Planning Application Ref.                      No: 24/5503

Applicant:    Tullacondra Green Energy Limited

We Donal and Sheila Gayer wish to lodge an appeal to the above application (Ref No 24/5503) which was granted Conditional Planning permission by Cork County Council on May 22<sup>nd</sup> 2025.

Fig5.1 protected structures within 5km of the proposed site EIAR report

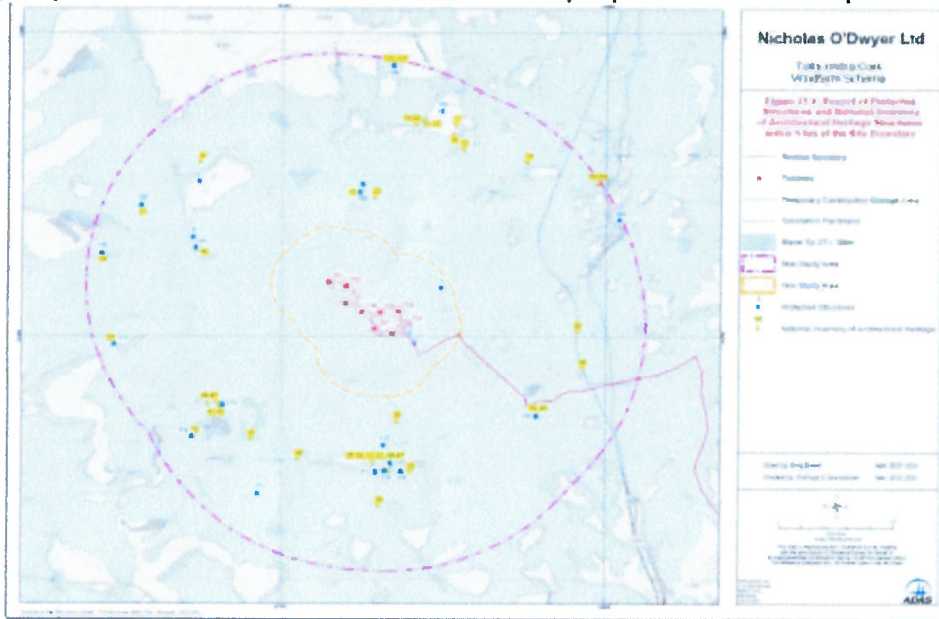
This map is not correct.. It excludes a Megalithic tomb (CO024-05602) of which no mention is made of any where in any archaeological report in the EIAR or in the RFI reply by the Archeologist.

This megalithic Tomb is located less than 2km from the proposed development. It is located approx 250 meters from the proposed Turbine Haul Route and Grid Connection route Option 2.

The Tomb dates back to C2000 BC and has not been mentioned in the RSK report 15.6.11 Prehistoric Period or in any section of the report

Fig 5..2 Location of Megalithic Tomb. Kilmaclenine

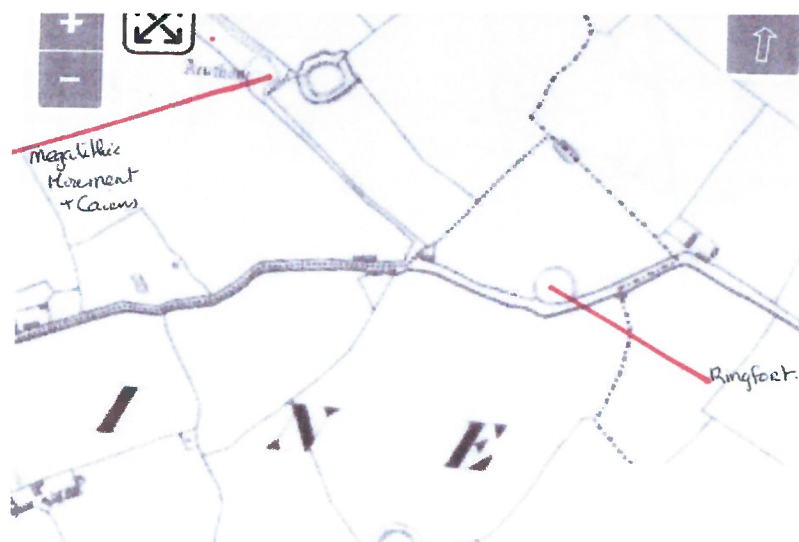
Figure 5.2 shows the presence of the megalithic tomb (CO24-05602) as well as the Ringfort (CO024-099) which hugs the proposed access road for proposed TDR haul route to the site. Sites and Monuments Record map 1928

The EIAR states that the potential effect will be “no Change/Neutral if ground works take place outside the buffer zone of the Ringfort. As per fig 5.2 The Ringfort and its buffer zone transverses the road to cover both sides of the road. There is no

Fig 5.4 Shows the approximate location of the Megalithic tomb and Cairns in the EIAR report map.

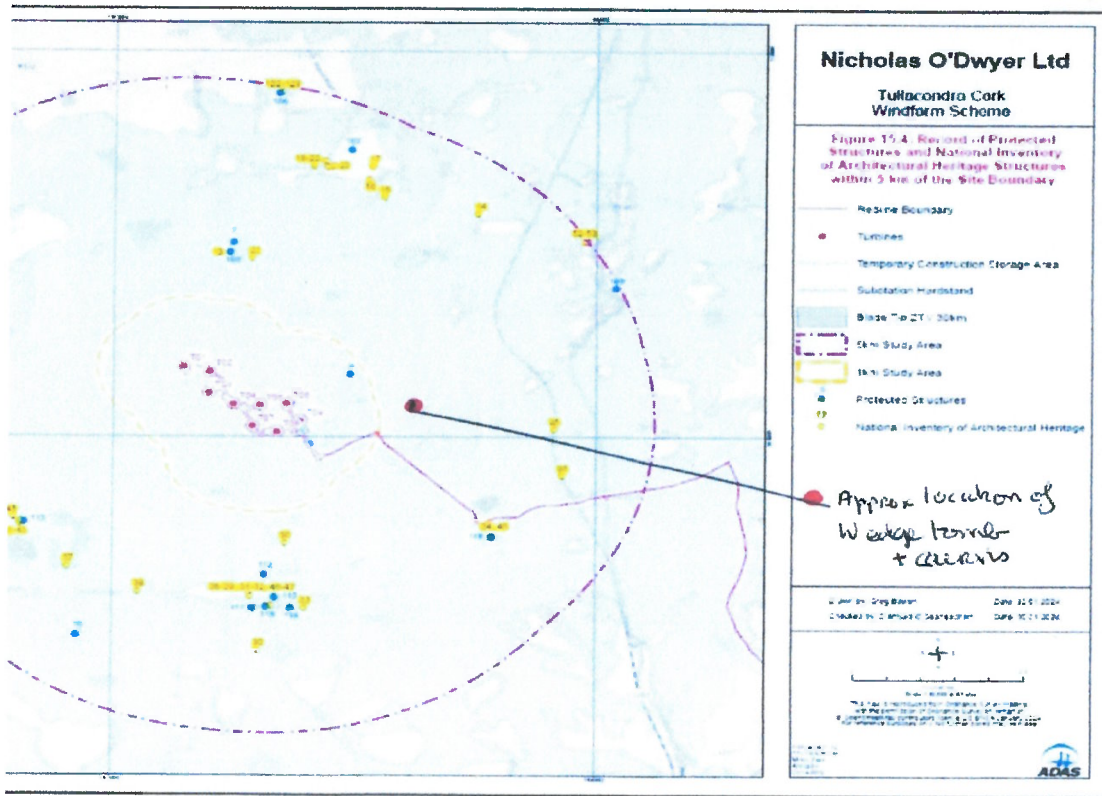
By omitting this structure in the EIAR assessment report there can be no guarantee that the structure itself or the surrounding area will not be impacted by the drilling, construction and traffic associated with the commissioning of the site and the Turbine deliveries and the Grid Connection operations.

Fig 7.1

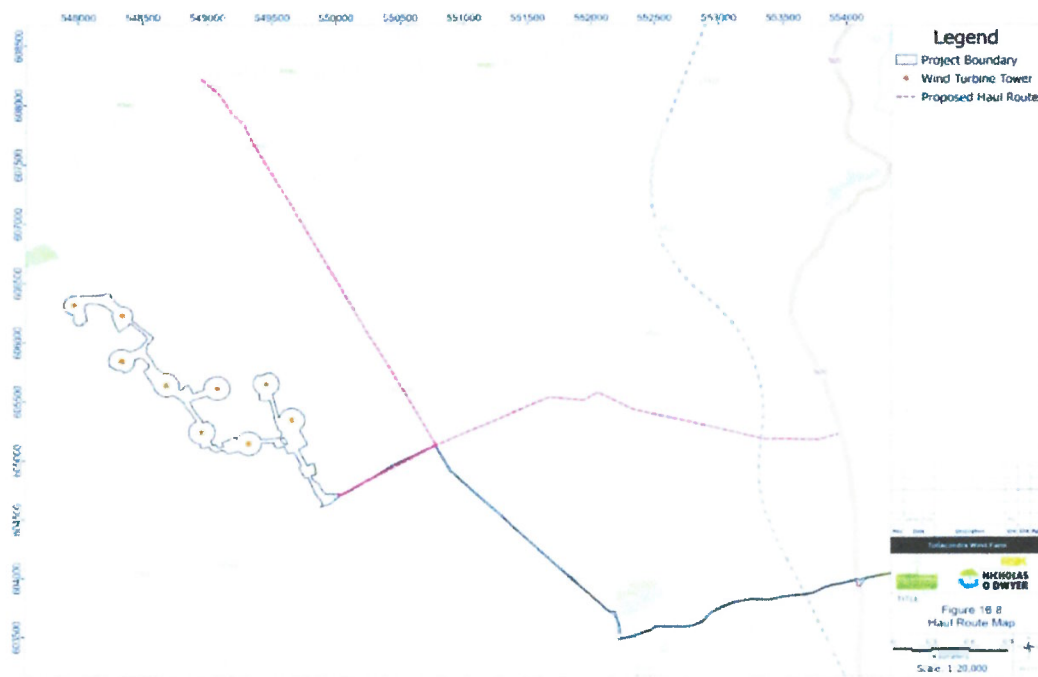
We live on the L5523 Boherash to Kilmacleanine road. The Gayer Family has lived here for nearly 2 centuries. 2 route options were given at the planning stage for the Turbine Delivery route. Option 1 has been shown in the RFI response as the proposed Haul Route Fig 7.1 Shows the “Proposed Haul Route”

Fig 7.1 Node 10 TDR Option 1

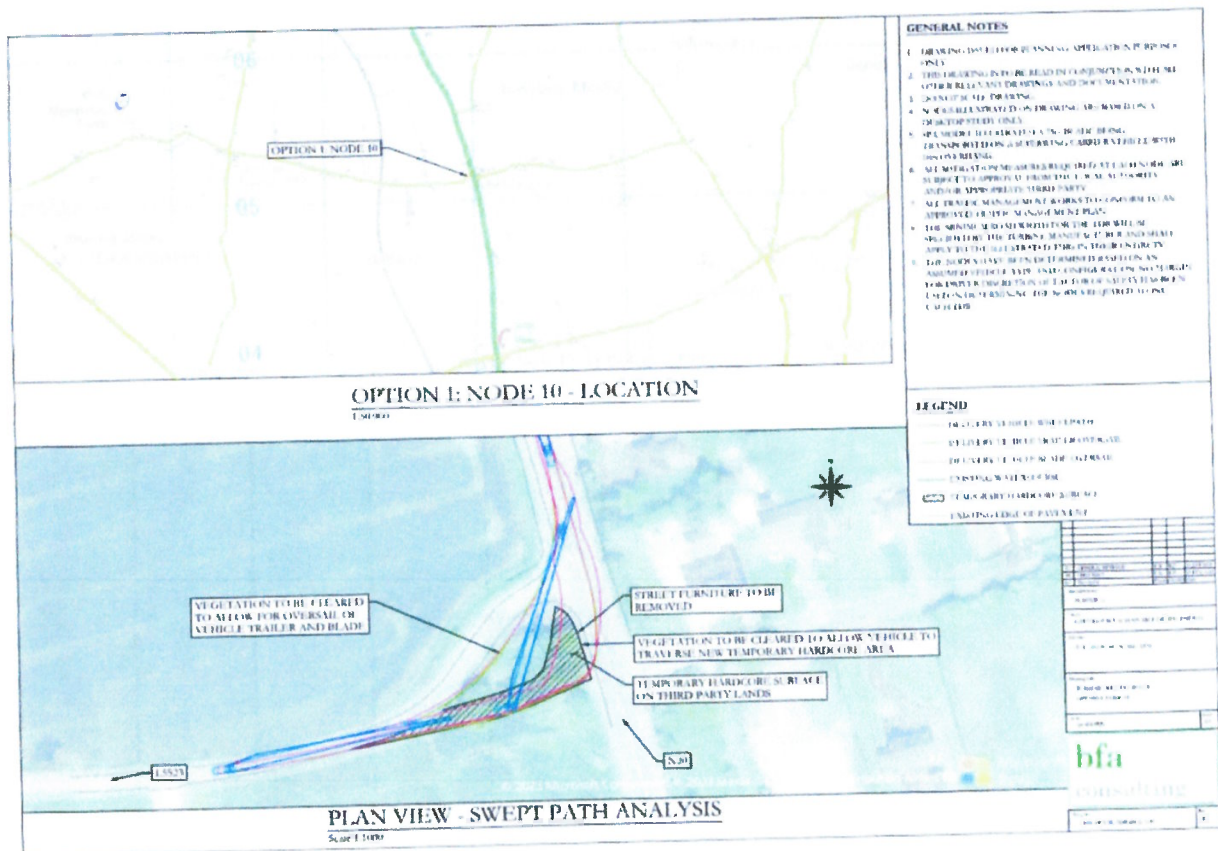
In TDR Option 1 Node 10 (Fig 7.1)A swept path analysis is visually shown on the map, taking out vegetation and laying of hardcore ( this node is one of the 2 areas outside of the proposed site where Japanese Knotweed((fig 3.1) is present )

Fig 7.7 Node 13 TDR Option 1

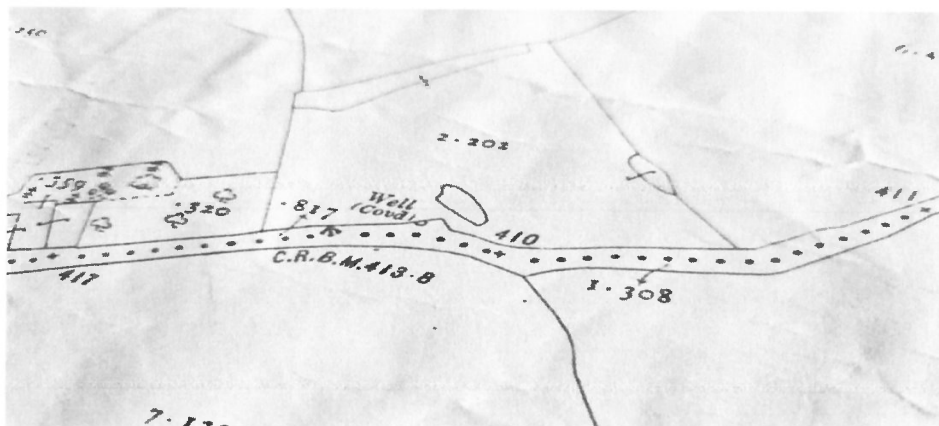
Node 13 (Fig 7.6) shows the proposed turbine route around the bends after the Ringfort. Hardcore surface is proposed here to allow delivery of the loads. These bends are on the perimeter of the "city field" where a settlement lived circa 1200 to circa 1600. This village and nearby settlements were flourishing in the 1400's. Earlier maps show the present of a well in the field (Fig 7.7). Many historical items may be found here if the area is dug up to make a hard core surface.. A full Swept path analysis has not been completed in this diagram (2 of 2)
